Space Nuclear
Thermal Propulsion Program
Particle Bed Reactor Propulsion
Technology Development and Validation

FINAL

SPACE NUCLEAR THERMAL PROPULSION PROGRAM

Particle Bed Reactor Propulsion Technology Development and Validation

Figure 2.3-2

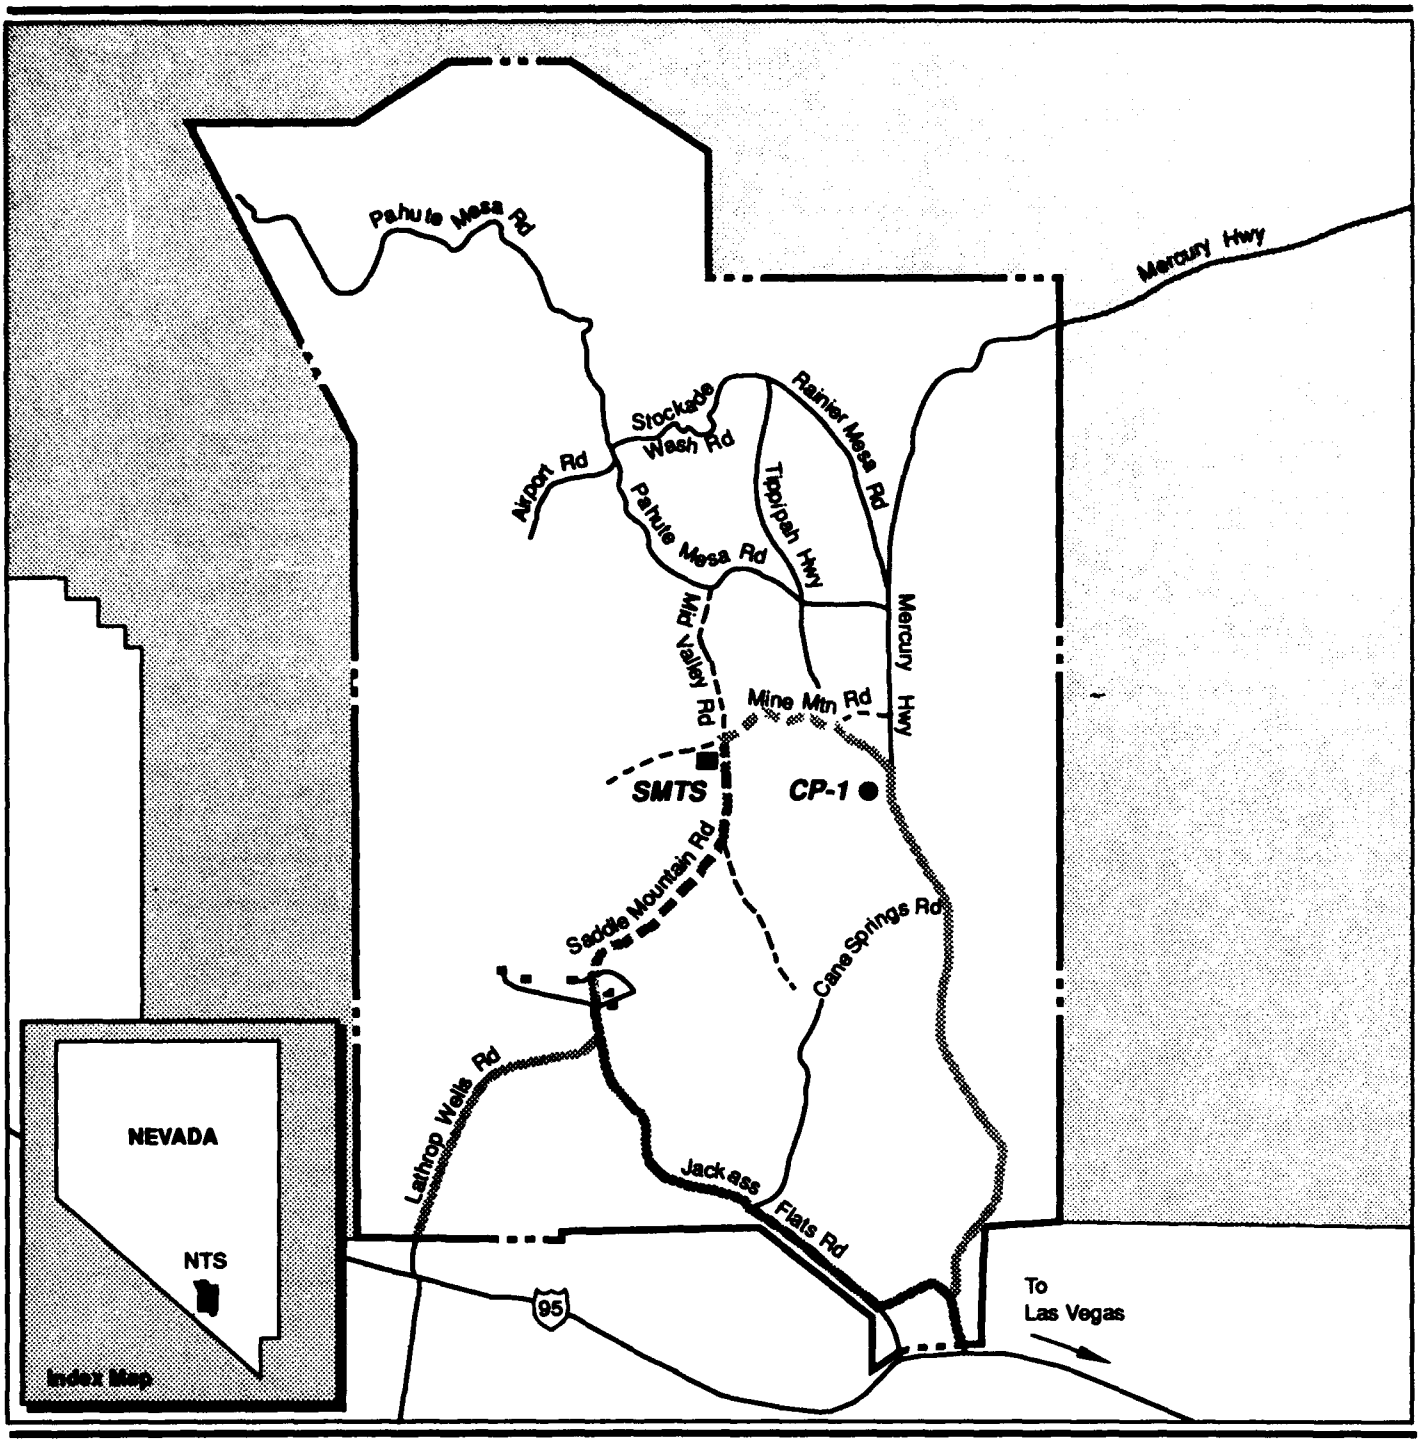
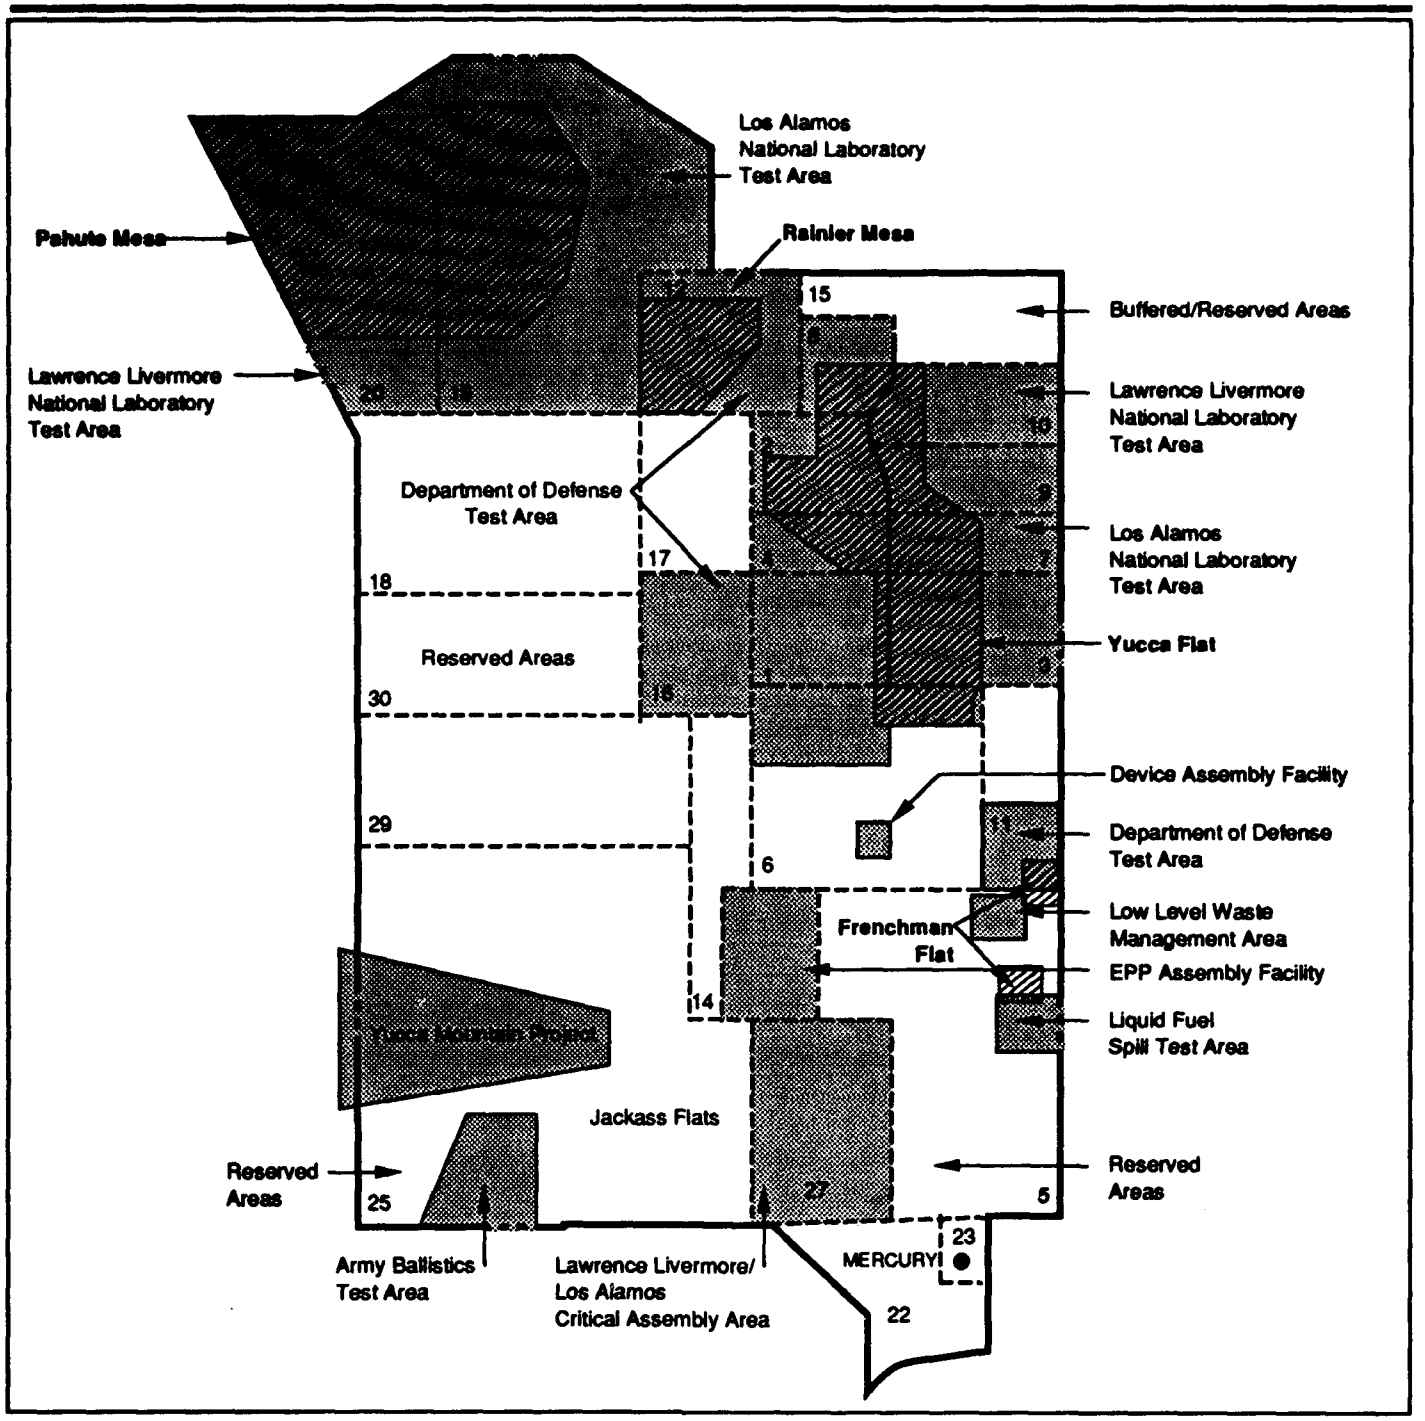
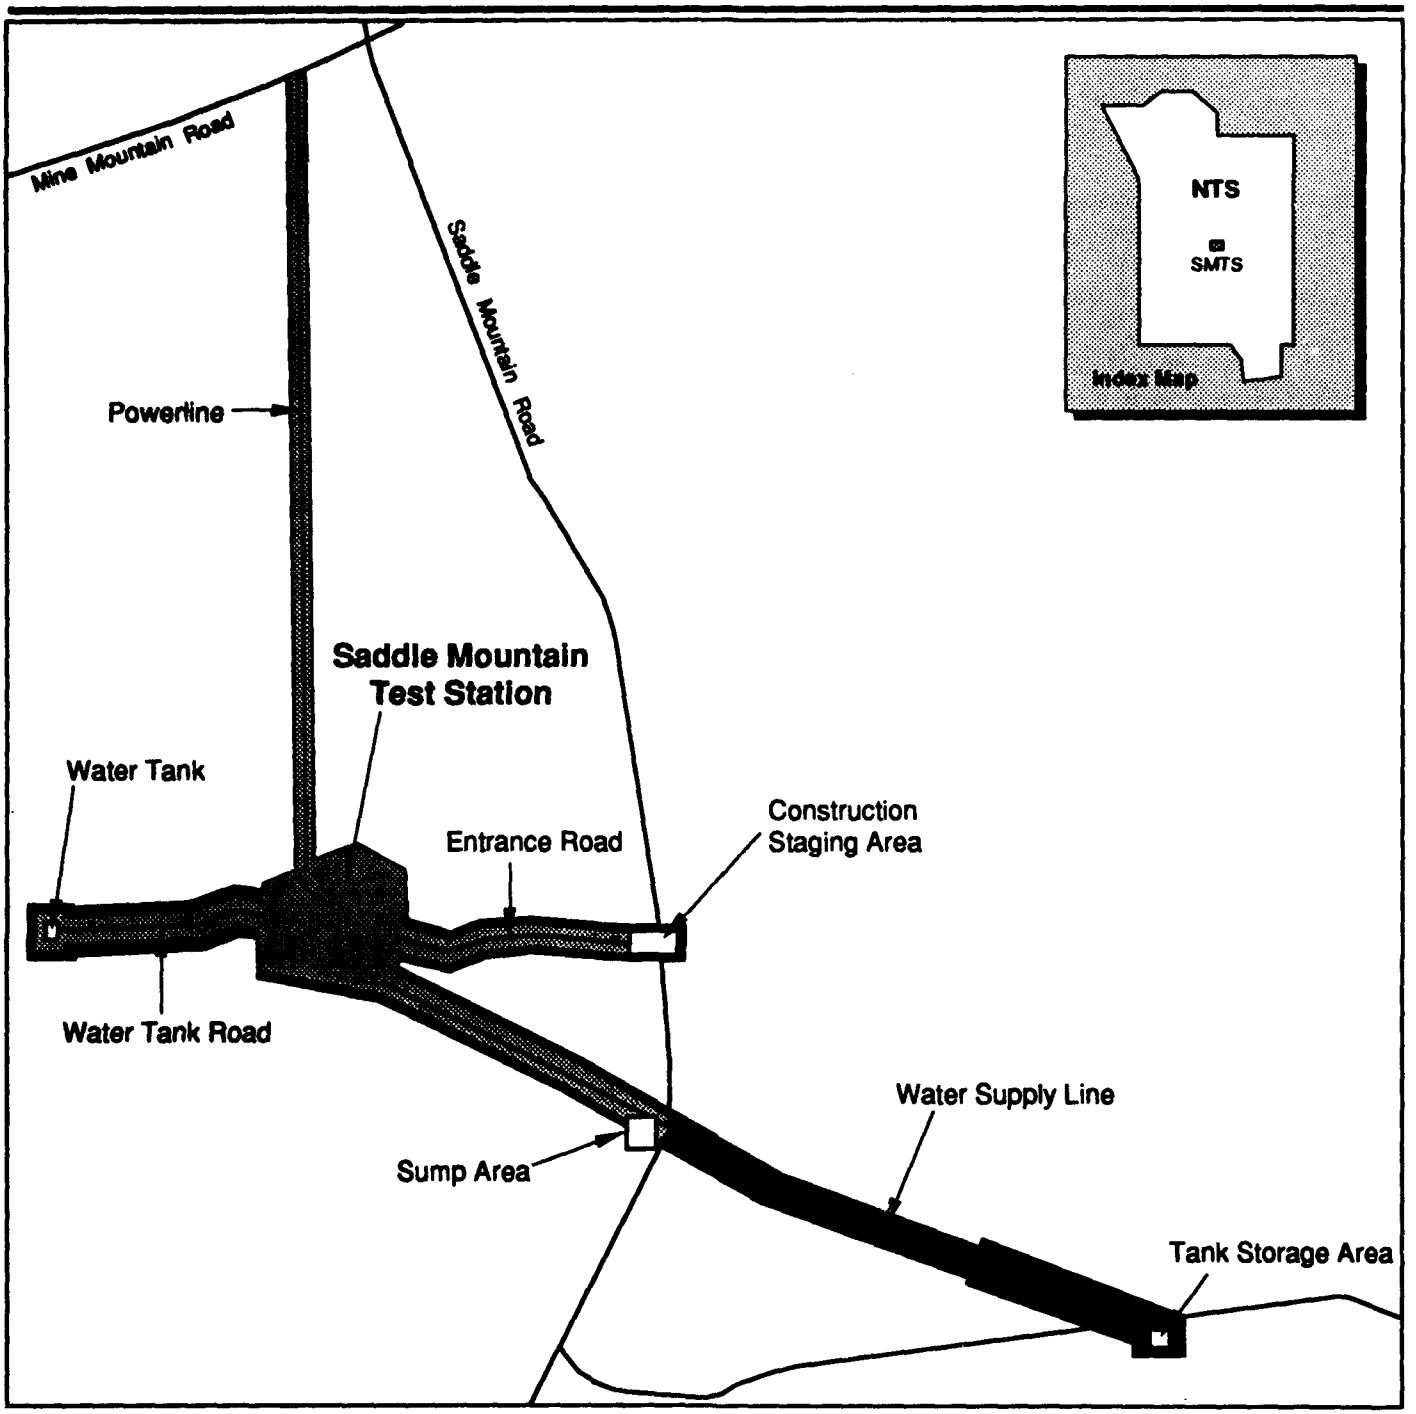
4 | 3. A comparison of the information in figure 2.3-2, figure 3.3-1 and figure 3.8-1 reveals a potential conflict between the security intensive activities contemplated in this DEIS and the public, civilian activities performed by the DOE Office of Civilian Radioactive Waste Management at Yucca Mountain. It is likely, given the number of public and special tours being conducted around Yucca Mountain, that tour busses may well wind up during either Jackass Flats Road or Lathrop Wells Road with shipments of "irradiated specimens" or engine components. This potential safety issue should be addressed in the DEIS.

Figure 4.12-2

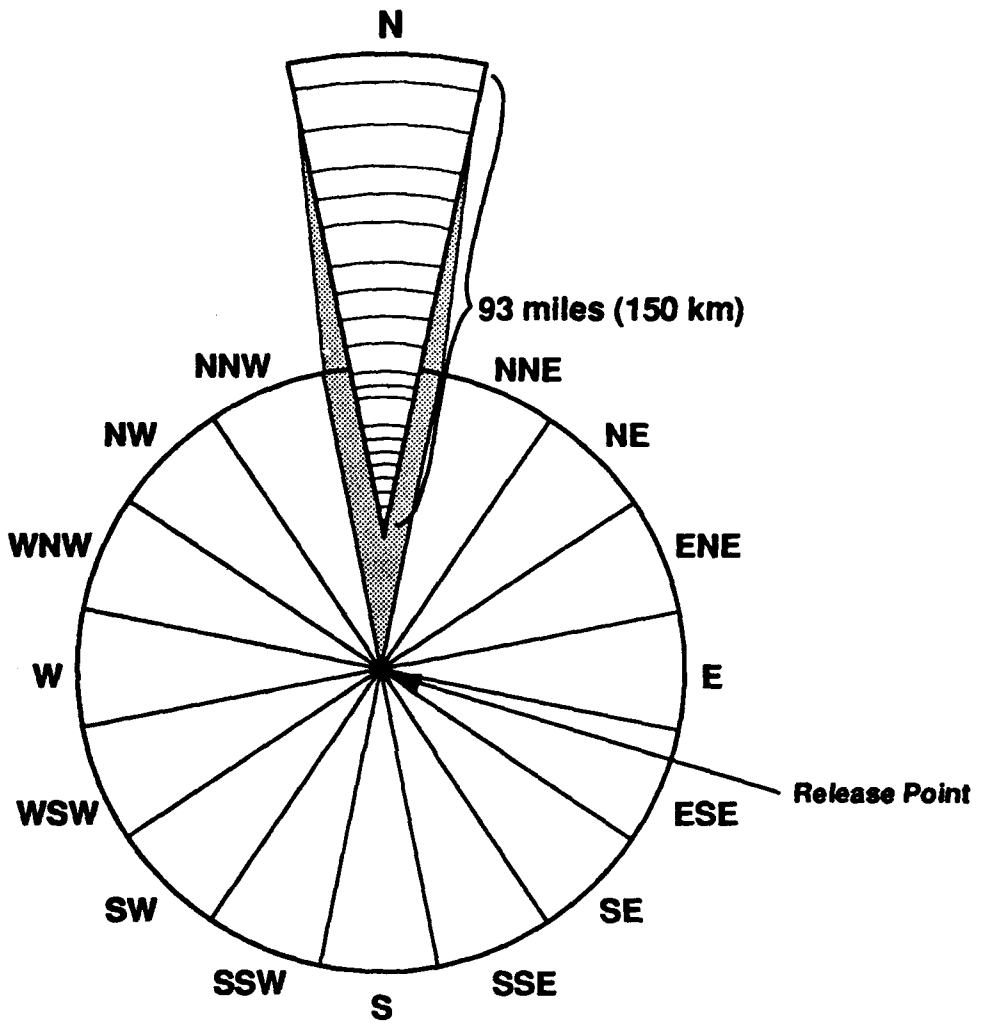
12.69 [27] The MACCS Polar data assumes equal population distribution throughout the grid. This is an inappropriate assumption based upon actual population patterns. Site-specific data should be used in this model. The DEIS used 1980 census data for parts of the model. Census data from 1990 is available and should be substituted. These inaccuracies could affect the person-rem dose. Figure E-1 includes shaded areas not defined and is not explained.

which has become available since the DEIS. Also, Figure E-1 has been revised to clarify the MACCS analysis methodology.

Figure E-1

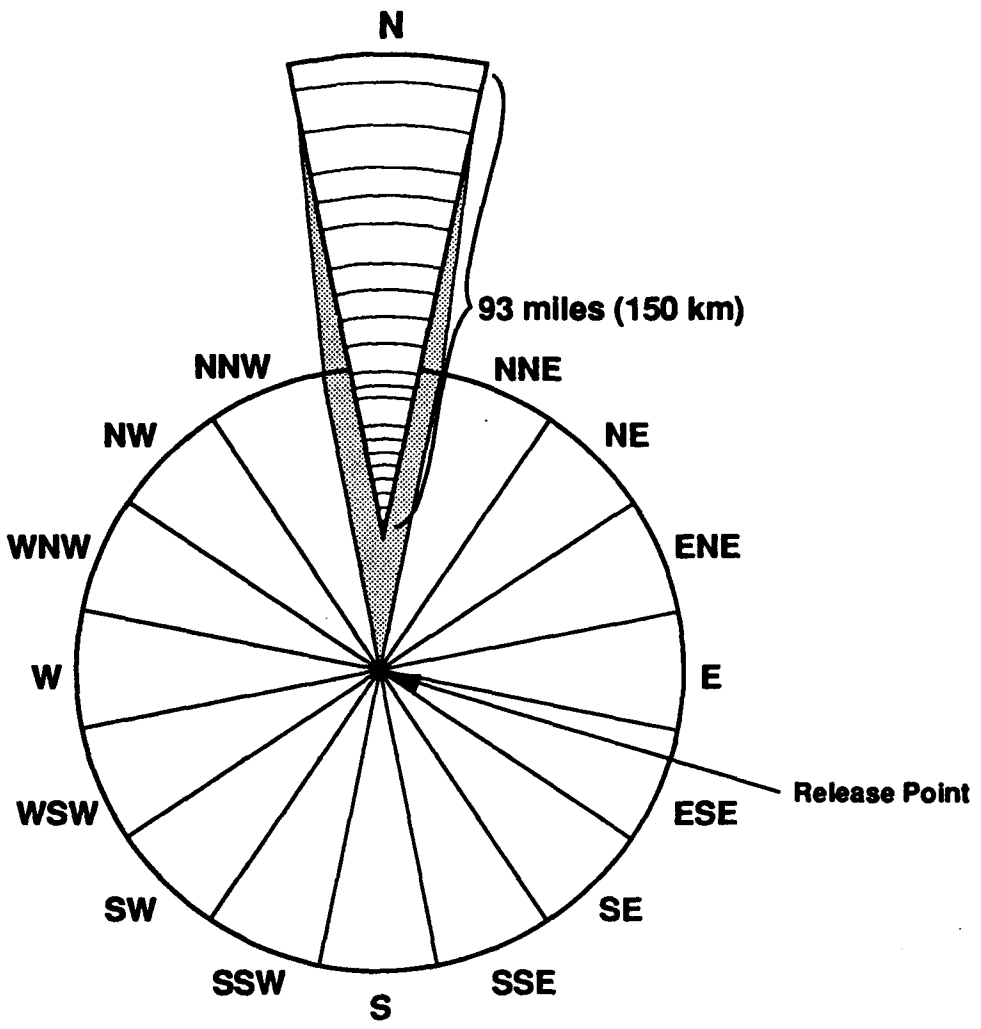
12.69 Comment: The MACCS polar grid does not represent population patterns; site specific data should be used. 1990 Census data are now available; the 1980 data should be updated; these changes would change the person-rem dose calculations. Figure E-1 includes shaded areas not defined and is not explained. (171-27)
